Introduction This bulletin introduces a new accessory alloy wheel for 1999 through 2001 model year Avalon, Camry, Solara and Sienna vehicles. This new wheel is similar in appearance to an existing alloy wheel. This bulletin points out that the two wheels are not interchangeable.

- **1999 – 2001 model year Avalon, Camry, Solara & Sienna.**

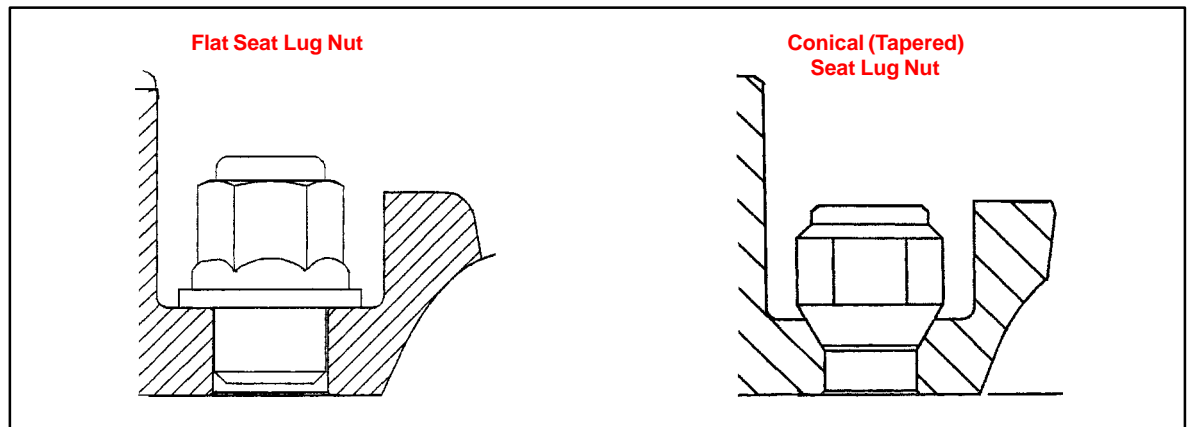
Every applicable vehicle must be installed with all four wheels of the same part number. In cases where replacement of one wheel is necessitated, it must be replaced by a wheel of the same part number. Replacement of one part number with the other is permitted only as a set of four wheels.

The service part numbers for the lug nuts are not interchangeable.

The service part numbers for the center caps are not interchangeable.
